**NORTH KERN WATER STORAGE DISTRICT**

Attached is Addendum No. 5 to the  
Specifications No. NK-619 for  
PIPELINE AND PUMP STATION PROJECT

### ADDENDUM NO. 5 TO THE SPECIFICATIONS NO. NK-619 for PIPELINE AND PUMP STATION PROJECT

ENLARGED PLAN NO. 8 - WELL 88-29-009  
SCALE: 1"=10'

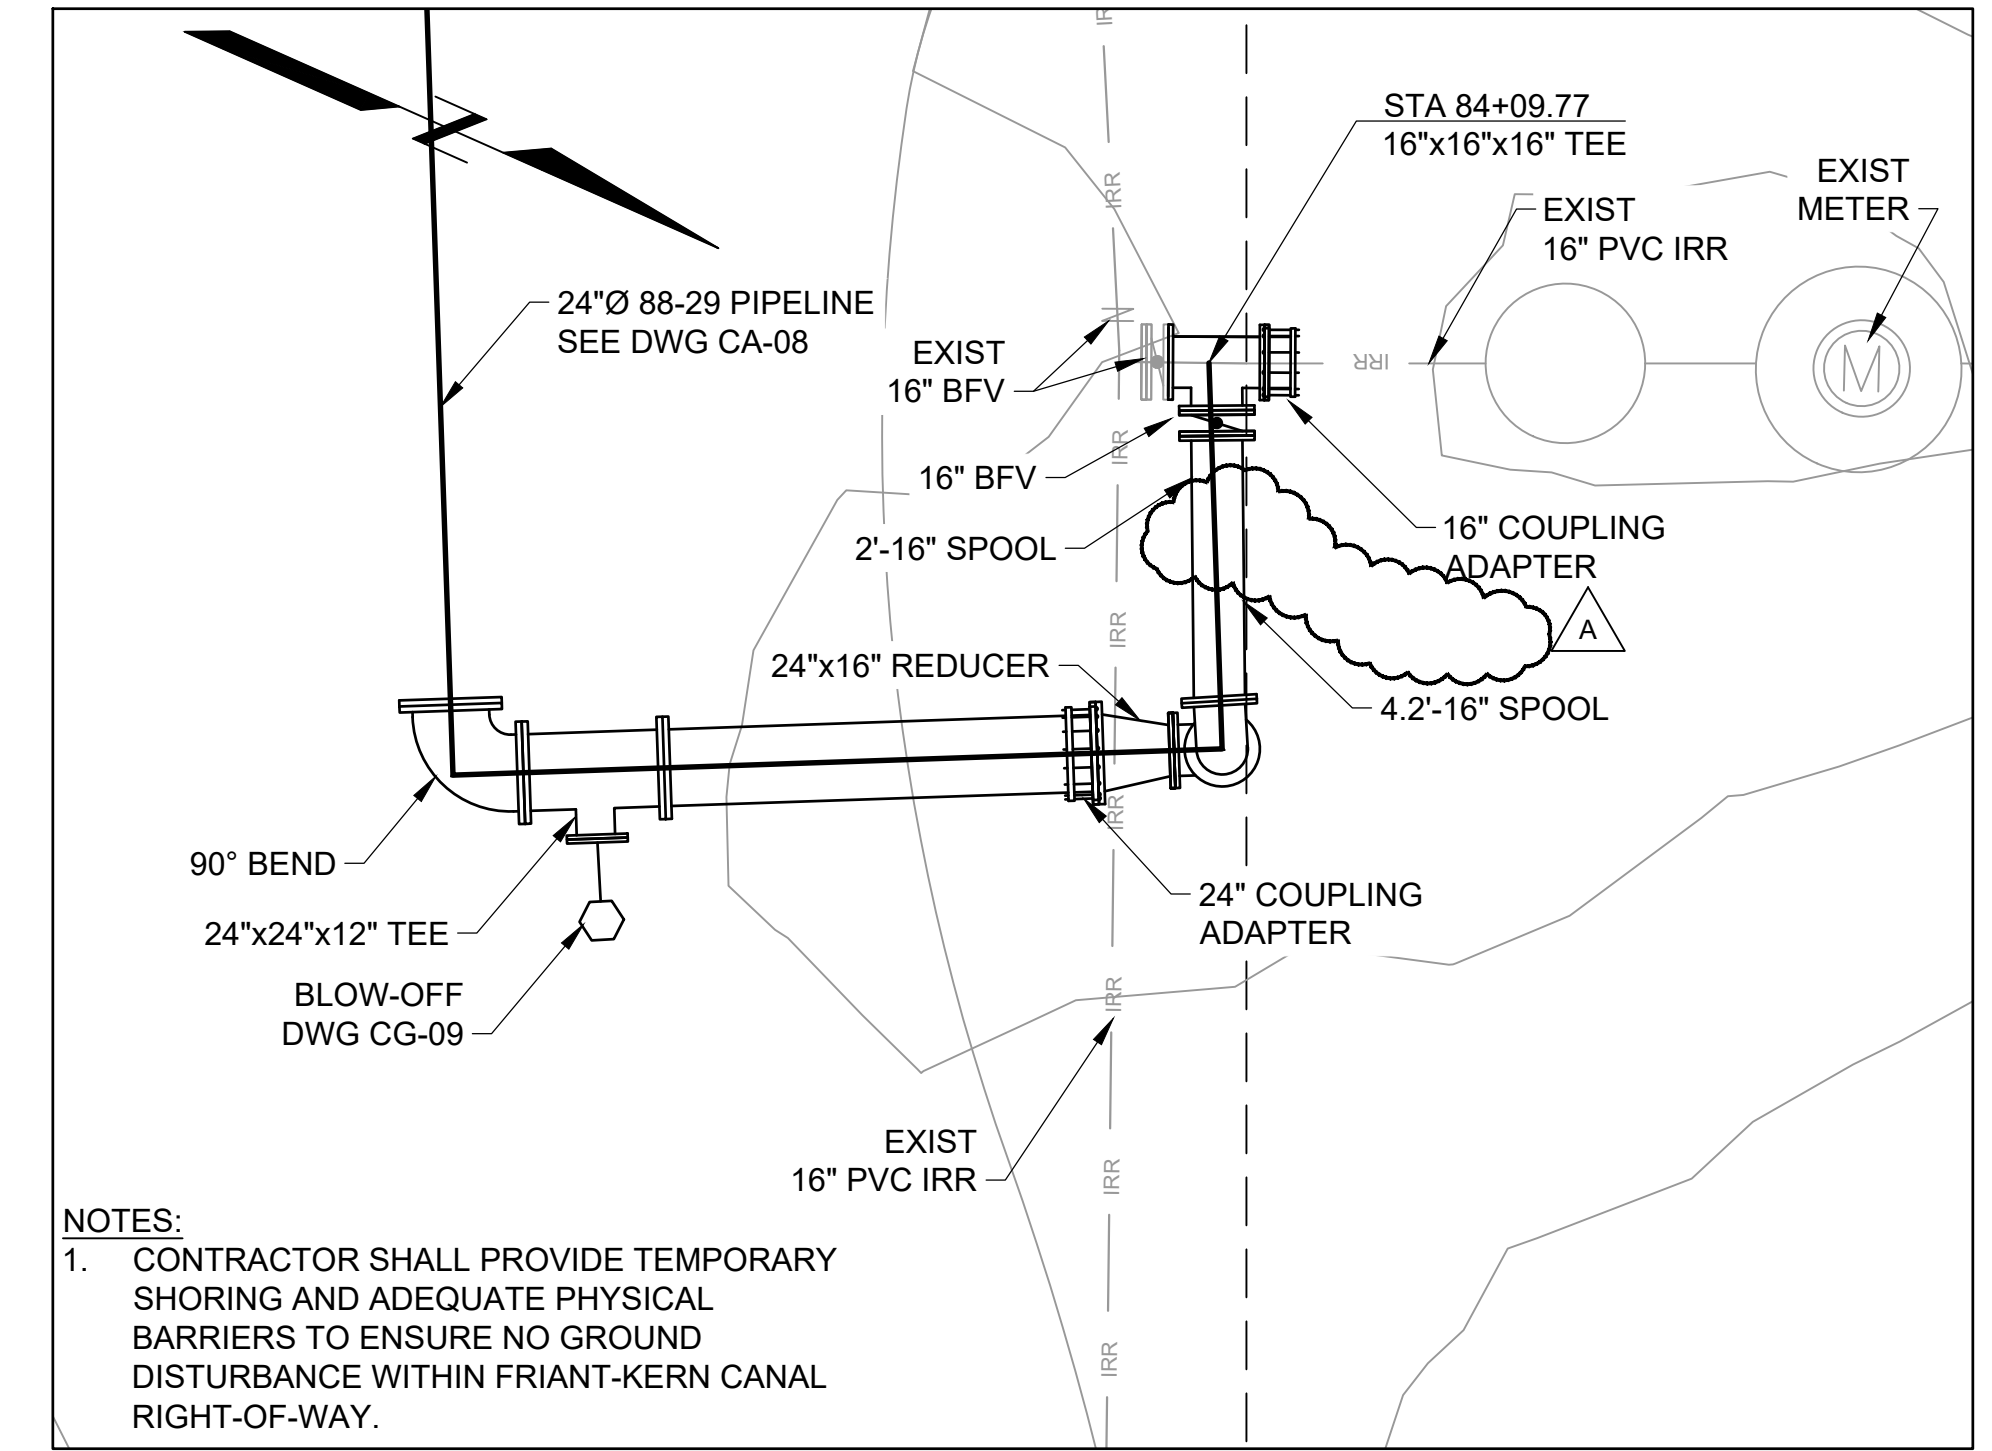
- ii. ENLARGED PLAN NO. 3 - WELL 99-00-026
  - iii. ENLARGED PLAN NO. 6 – WELL 99-00-022
- e. Drawing No. C-102. Sheet No. 44.
  - i. ENLARGED PLAN NO. 8 – WELL 88-29-009. Revised well connection gooseneck assemblies and mag meters to “EXIST”. Deleted Note 1.

ENLARGED PLAN NO. 9 -  
CONNECTION TO EXISTING 16" PVC IRRIGATION  
SCALE: 1"=10'

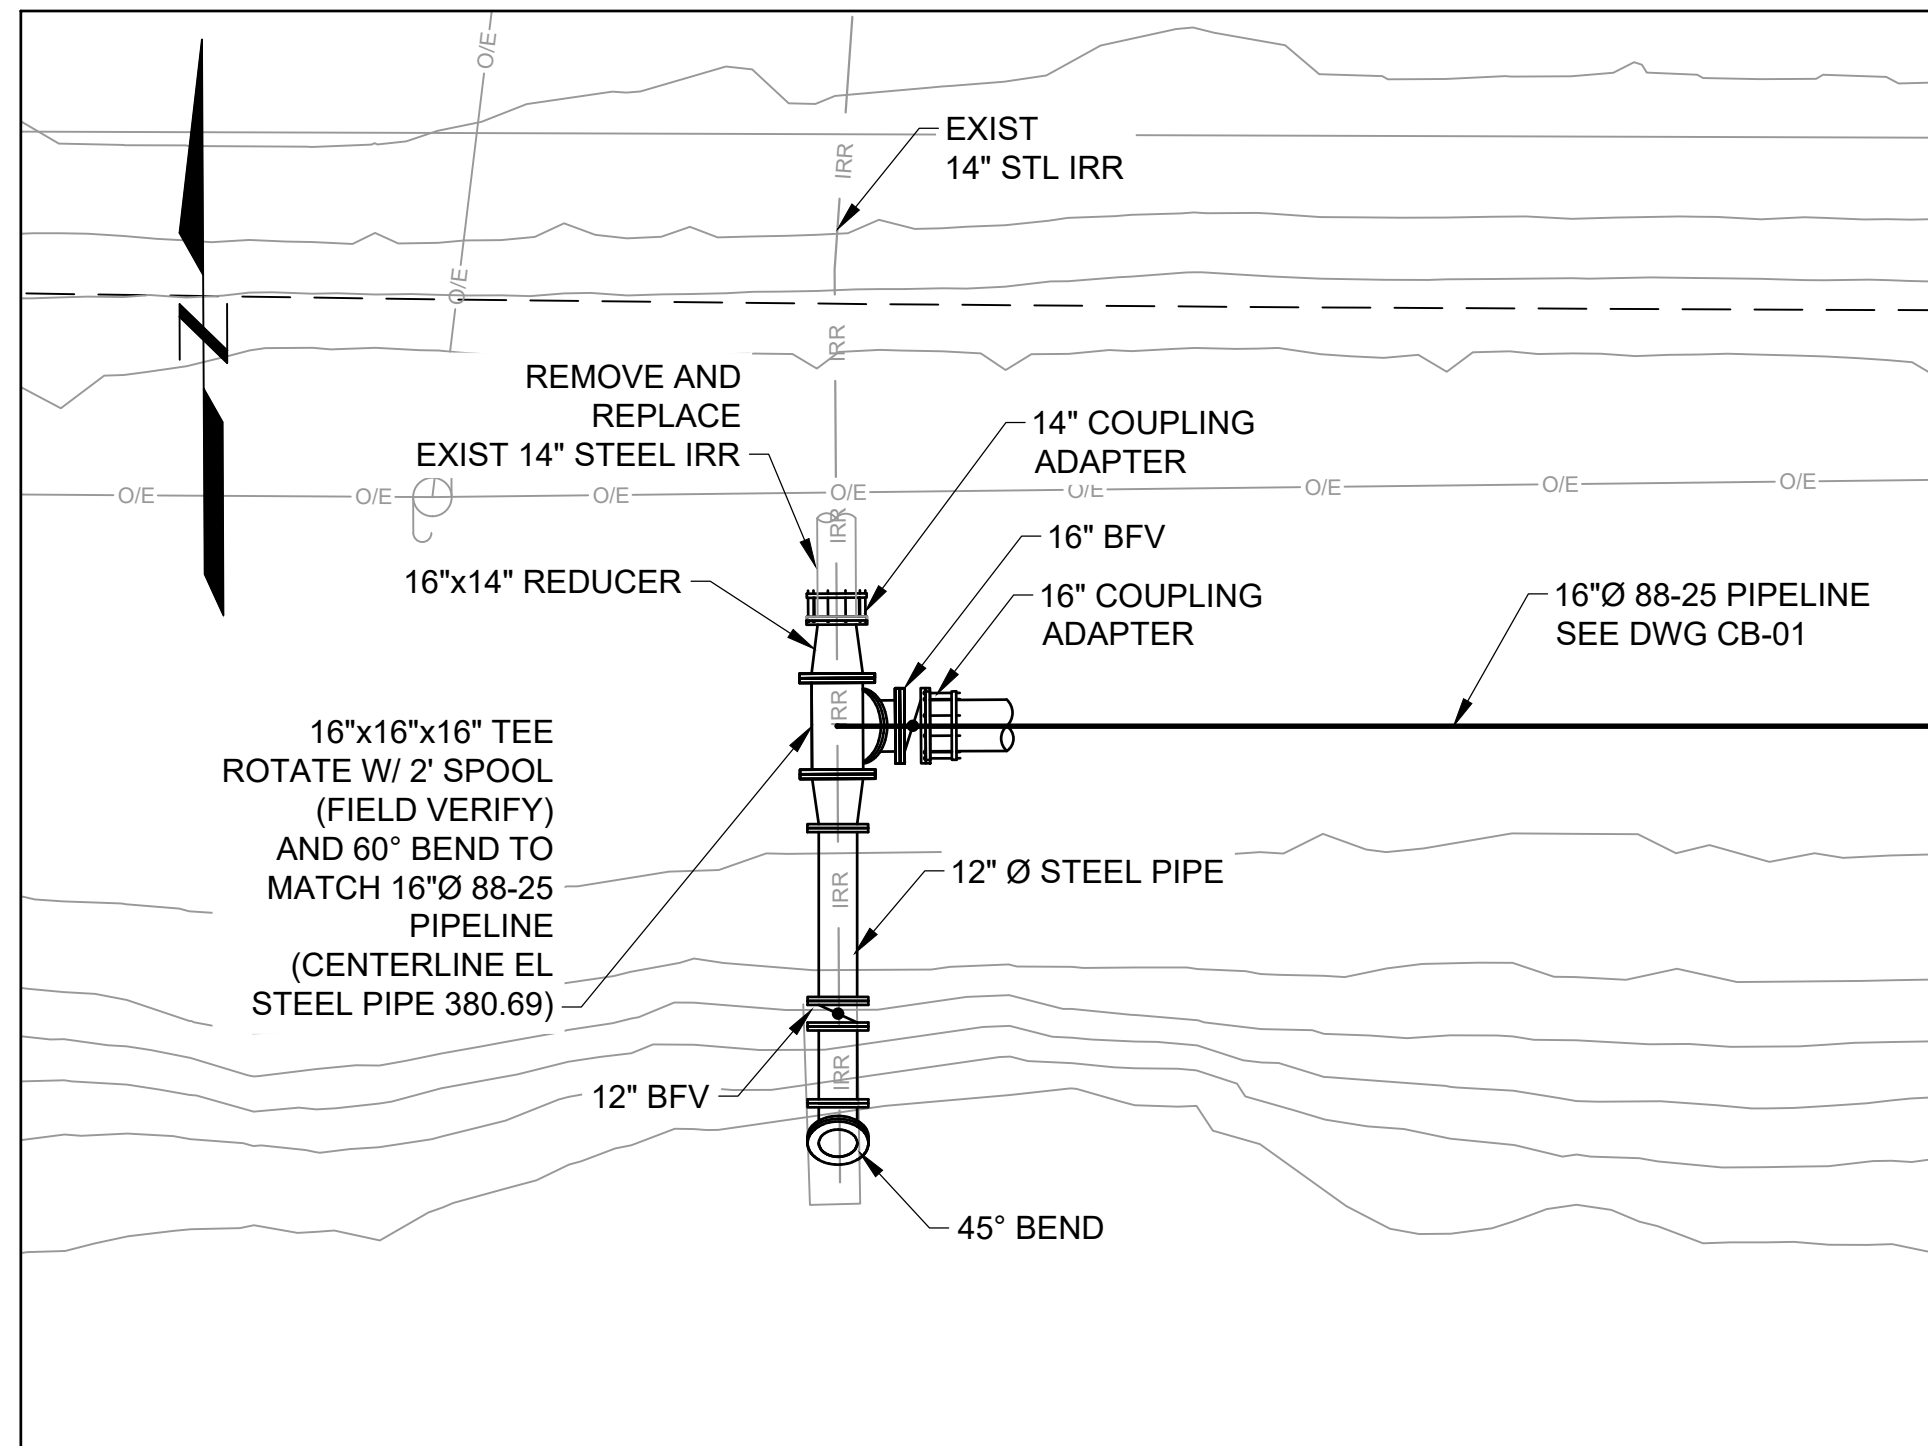
- ii. ENLARGED PLAN NO. 9 – CONNECTION TO EXISTING 16” PVC IRRIGATION. Deleted 16” CV.
- f. Drawing No. C-103. Sheet No. 45. Deleted Detail 1. Added General Note No. 8 “INSTALLATION OF NEW EQUIPMENT, INSTRUMENT, VALVES, FITTINGS, AND APPURTENANCES SHALL NOT BE INSTALLED WITHIN 1X PIPE DIAMETER DOWNSTREAM OF EXISTING MAG METER, OR 2X

ENLARGED PLAN NO. 13 - WELL 88-29-006  
SCALE: 1"=5'

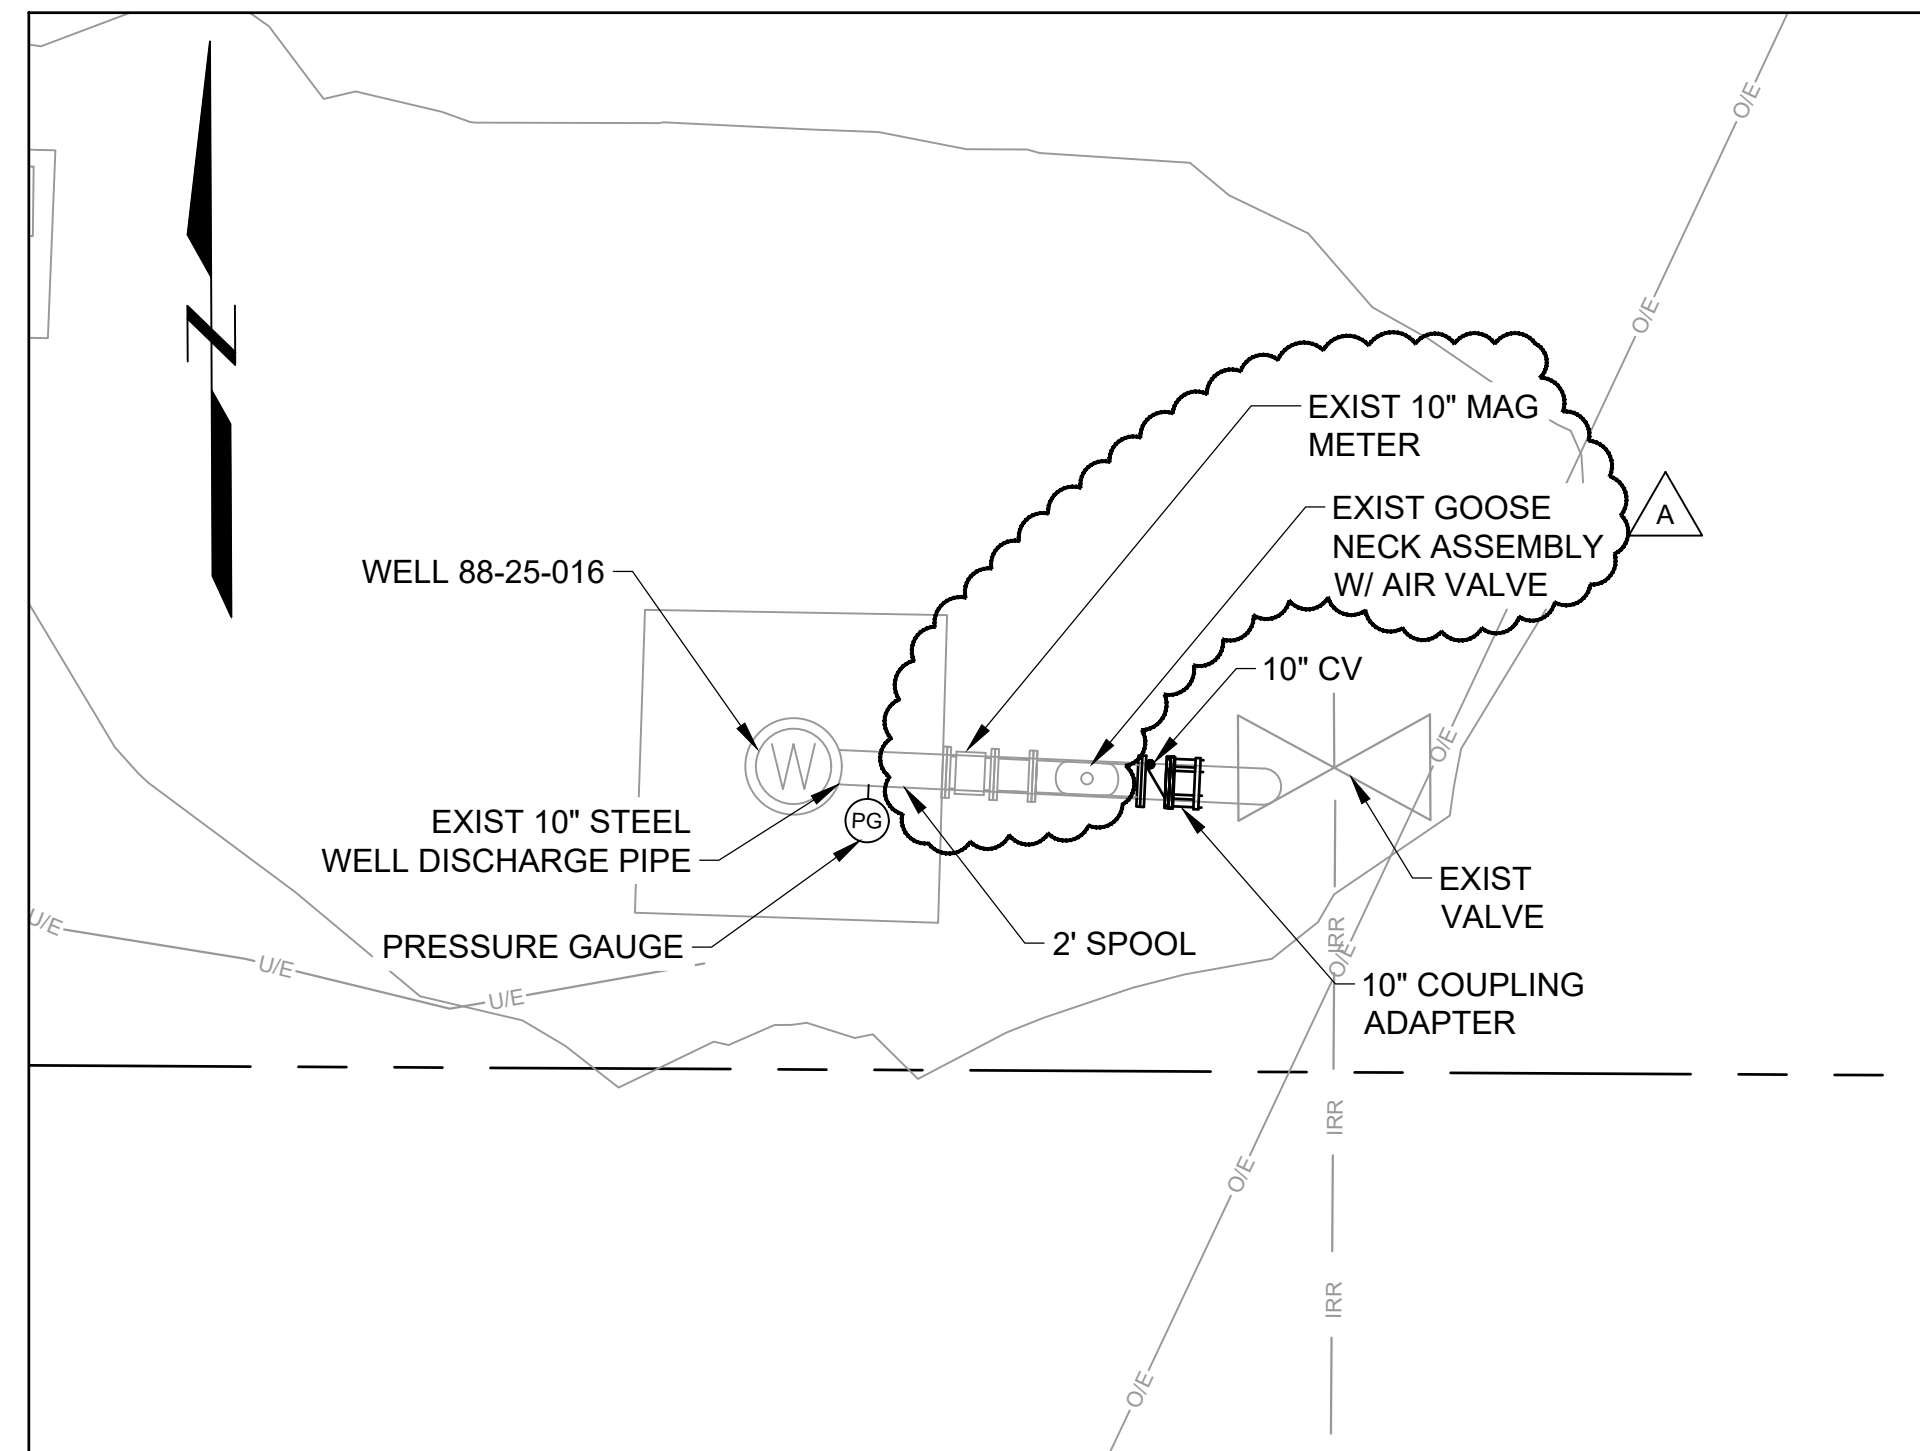
Revised well connection gooseneck assemblies and mag meters to “EXIST” for the following details:

- i. ENLARGED PLAN NO. 13 – WELL 88-29-006
  - ii. ENLARGED PLAN NO. 14 – WELL 88-25-016
  - iii. ENLARGED PLAN NO. 17 – WELL 99-00-032
- g. Drawing No. C-104. Sheet No. 46. Added General Note No. 5 “THE MINIMUM LENGTH OF UNOBSTRUCTED STRAIGHT PIPE FOR THE 18” MAG METER SHALL BE 36” UPSTREAM AND 18” DOWNSTREAM OF THE METER”.
